GROUP	MODEL
Emissions Service Campaign	2020MY Sportage (QL) w/2.0L T-GDI
NUMBER	DATE
SC222	April 2022

VEHICLE EMISSION CONTROL INFORMATION (VECI) LABEL REPLACEMENT (SC222)

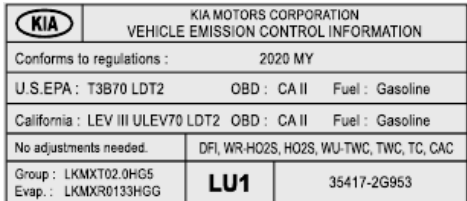
4. Carefully affix the new provided VECI label over the old VECI label, ensuring complete coverage of the old label with the new one.

Ensure the correct label (2WD or 4WD) is affixed to the vehicle. Refer to Parts Information for proper part number.
